Stateside Subdivision

SUBFY 2025-0002

Preliminary / Final Plat

July 8, 2025

Access

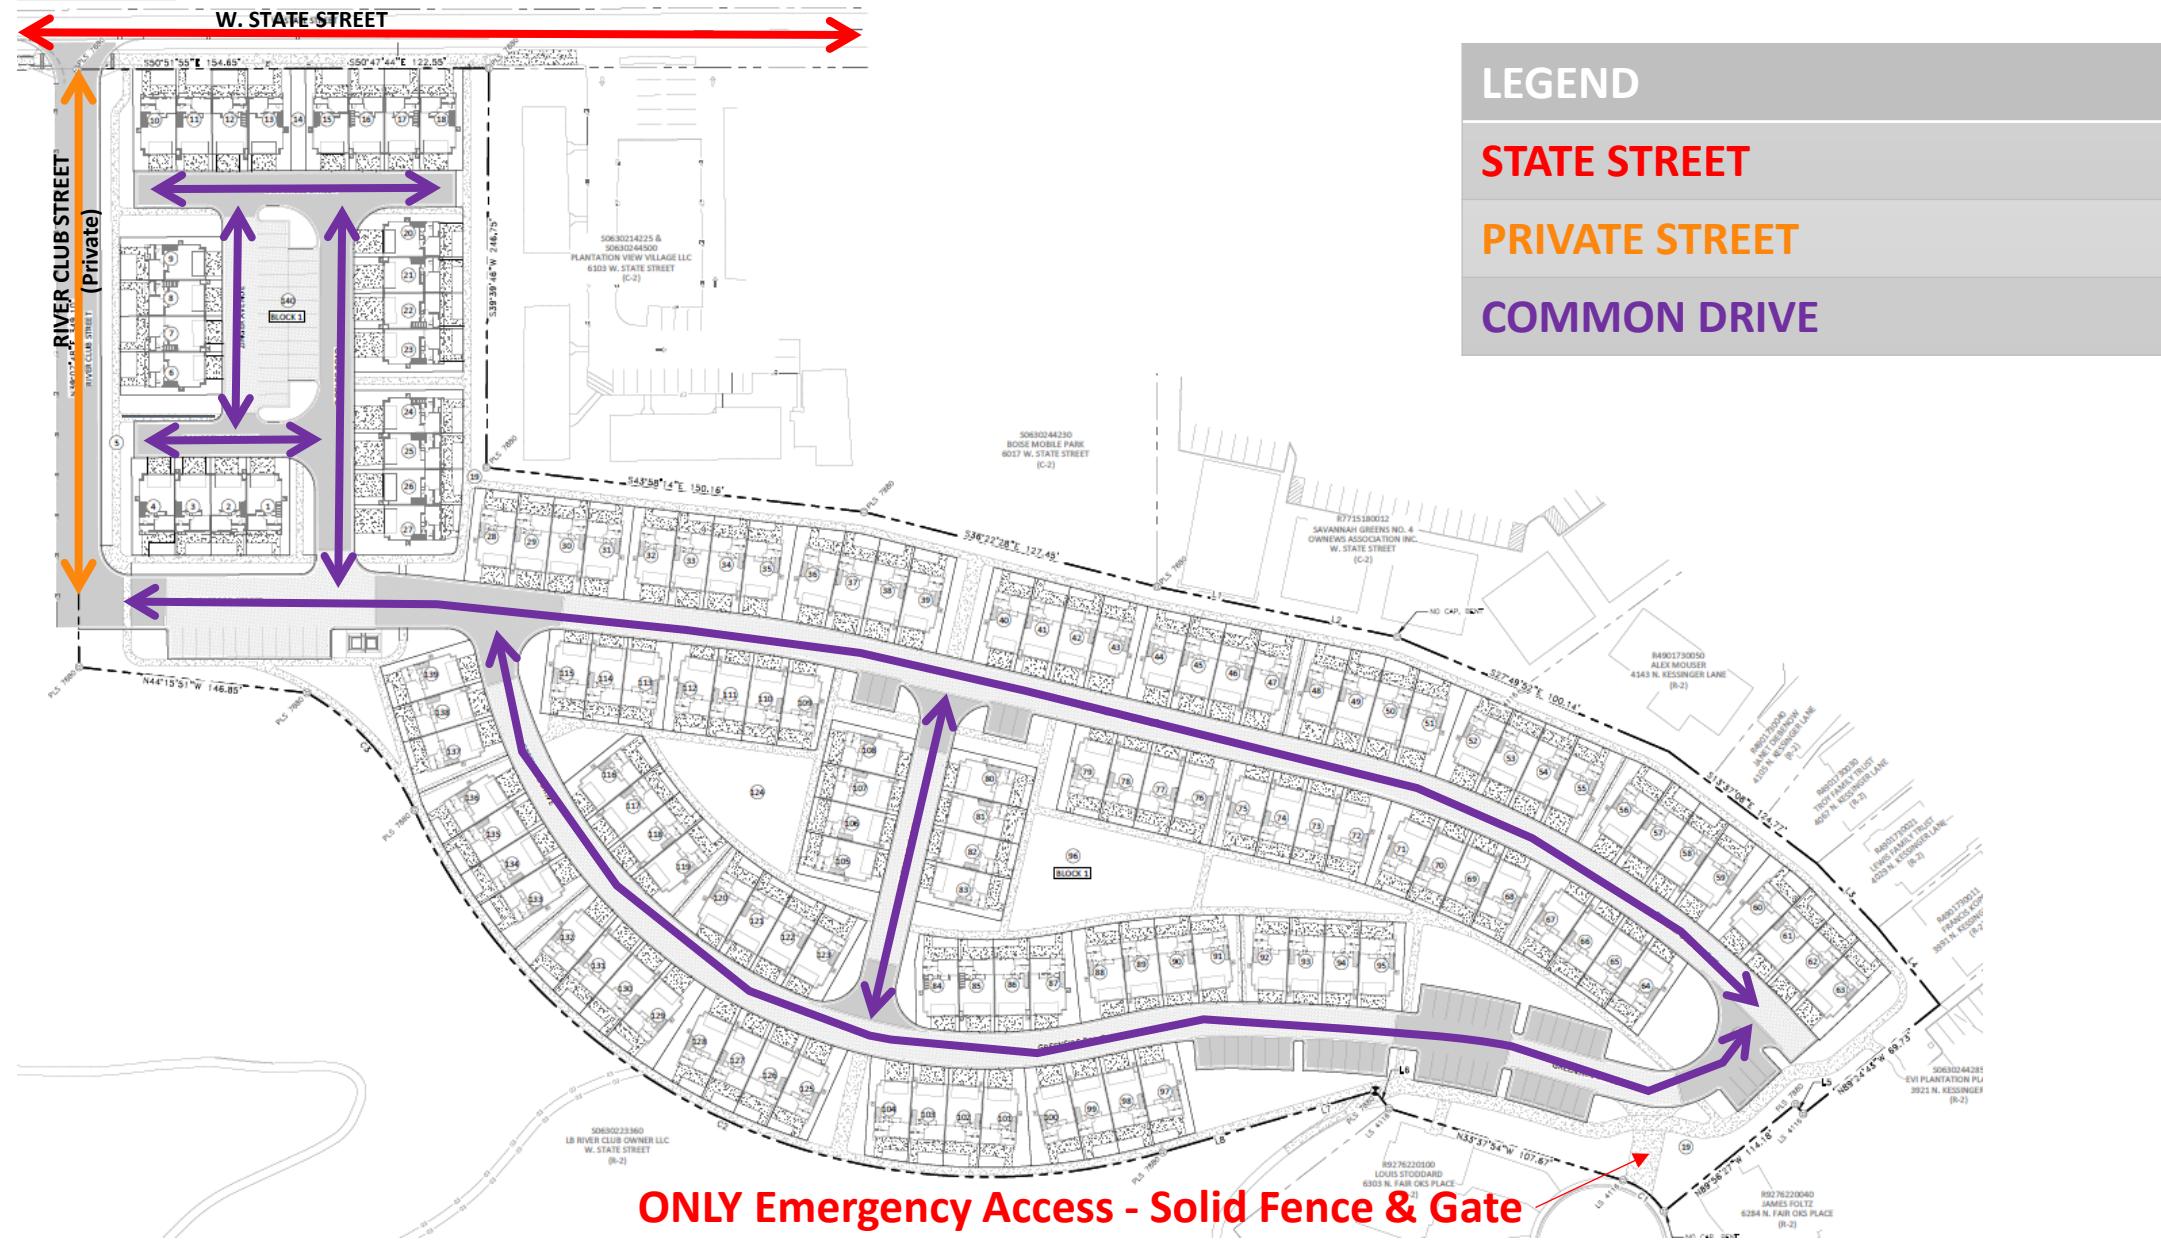
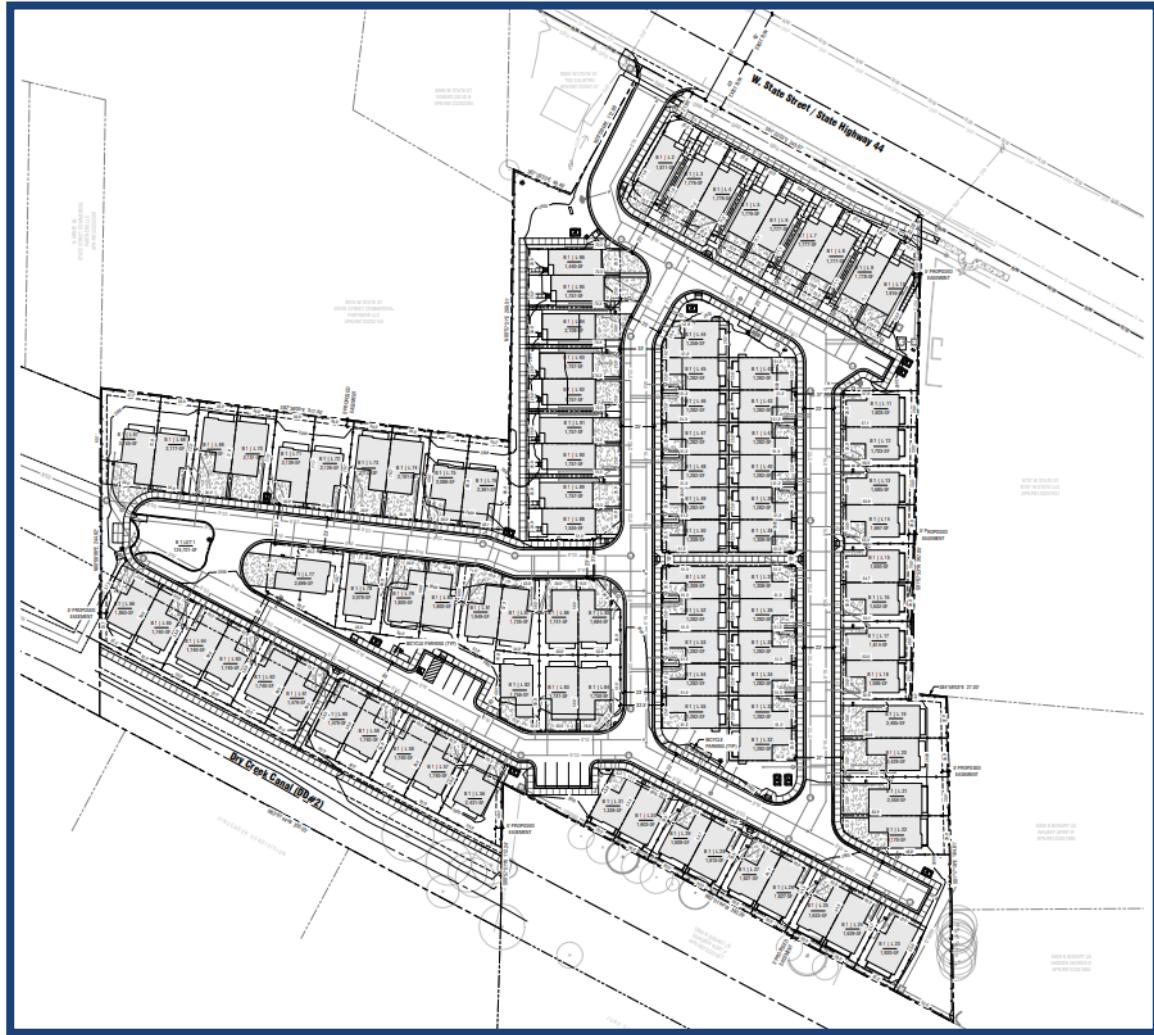
Vehicular Access Designation

- River Club Drive (Private Street)
- Common Drive (shared access)

The Staff Report has Misapplied “Parking Area” to include Residential “Garages” for Single Family Detached, Attached and Townhouses. In Garden City the following standards **CANNOT** be met where:

- Vehicles stored in a **Garage** could leave or enter in a forward motion. (**GC 8-4D-3A.7.a / SAP 8-8A-3D-3A.6.a**)
- Vehicles in a **Garage** are able to turn around within the site boundaries. (**GC 8-4D-3A.7.b / SAP 8-8A-3D-3A.6.b**)

Garden City Code Section 8-4D-3 and Residences at River Club Code Section 8-8A-3D-3 are the SAME and clearly refer to **Parking (lot) Area** standards and requirements — not residential **Garages** contained within a lot or residential unit.

If interpreted, Garden City is unable to approve ANY single family detached, attached or townhome development unless vehicles can:

- Enter and leave in a forward motion; **AND**
- Turn around within the site boundaries.

- Designate all internal access lanes as COMMON DRIVES

- Remove all references to “PARKING AREA” because they DO NOT APPLY to Single Family & Townhome within the SAP or Garden City Code.

Sidewalks & Pathways

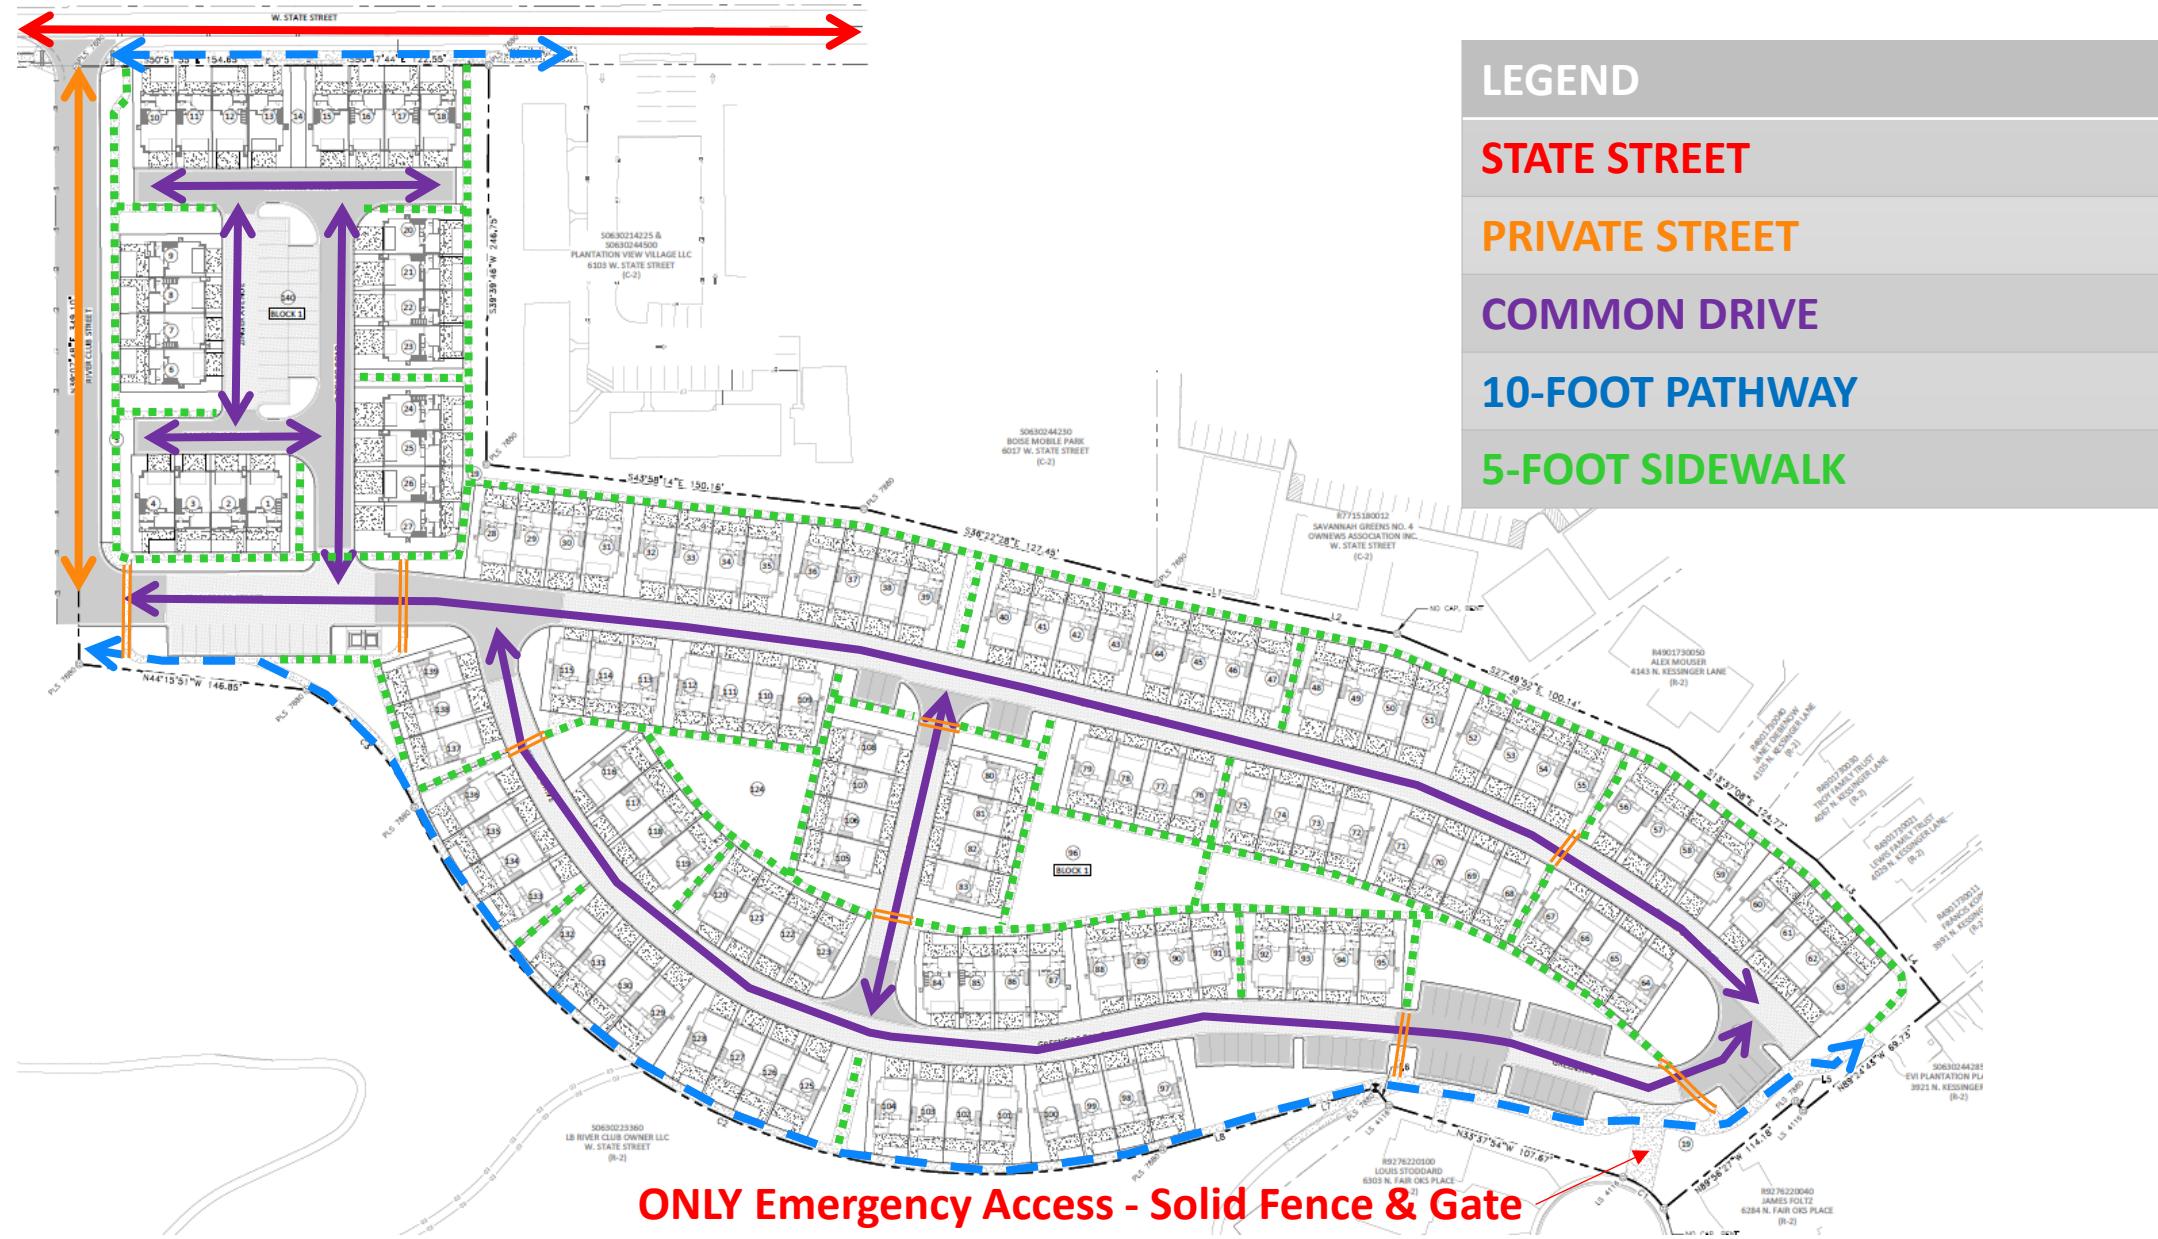
Primary Home Entrances are accessed from:

- Sidewalks (5-foot)
- Pathway (10-foot)

Garages are accessed from Common Drives (shared access lane).

Stateside provides over 1.15 miles of new sidewalks and pathways.

- Remove all references to “Does Not Meet Sidewalk Standards” can be removed
